**doc.: IEEE 802.11-99/075**  
**IEEE 802.11**  
**Wireless Access Method and Physical Specification**

Title: **Figures for Interleaver Proposal**

This submission provides clarifying figures for the proposal made in 99/074 by Tal Kaitz and Naftali Chayat. The changes are made to the interleaver definition consistent with standard formats.

Figure 2. Modified 16QAM interleaver with cyclic shift.

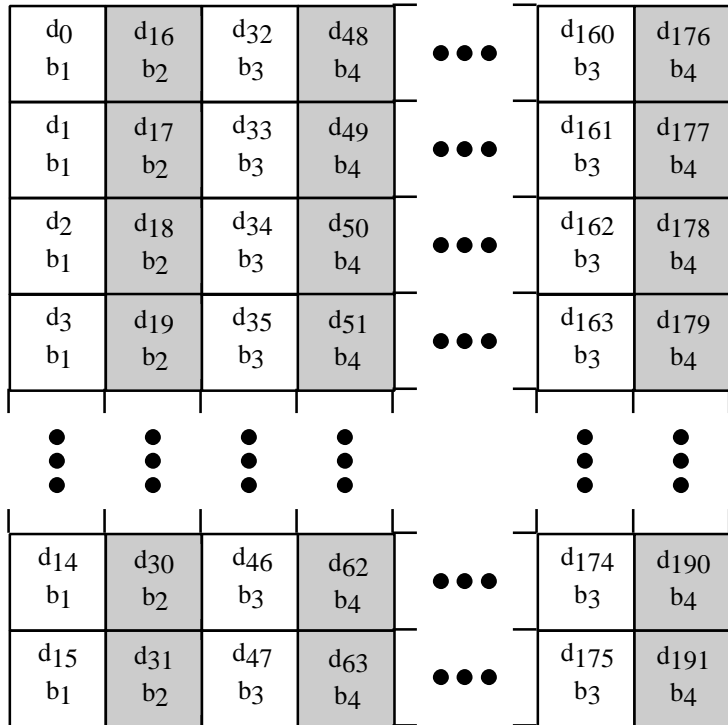
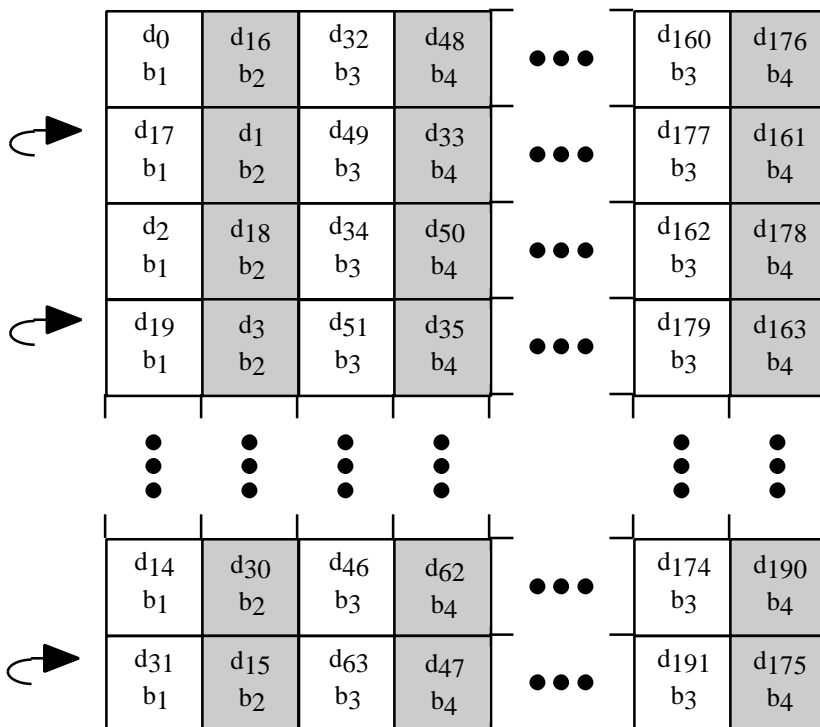
Figure 1 illustrates the current interleaving with symbol mapping. The proposal in 99/047 and in my comment in LB16 is as shown in Figure 2 for 16QAM. There is a cyclic shift of 1 bit every other row to effectively interleave bits coming from LSB's and MSB's. Figures 3 and 4 show the current and proposed interleaving for 64QAM.

The D3.0 draft of Tga is not overly generous in describing the interleaver output to symbol mapping. The following figures which describe the modified interleaver ordering (figures 2 and 5) and appropriate text should be included in the draft to clarify the interleaver output to symbol mapping
